SOLDER ISA SLOT COMPONENT

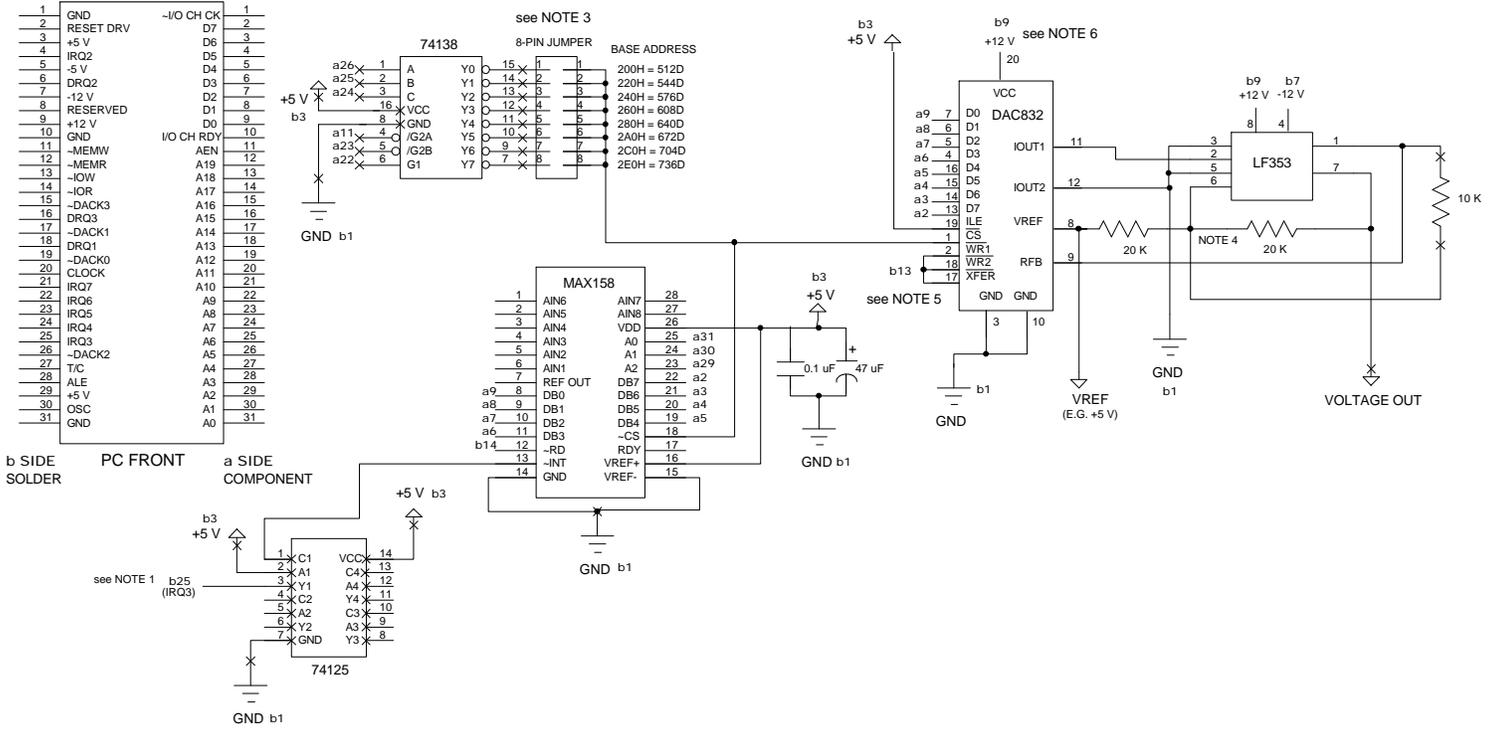
NOTE 4: 09/14/00 Added dot inbetween the two 20K resistors to make the connection clearer

NOTE 5: 02/05/01 DAC0832 pins 2, 17 and 18 should connect to /IOR (b13) not GND

NOTE 6: DAC0832 pin 20 connects to +12V (but +5V probably OK too)
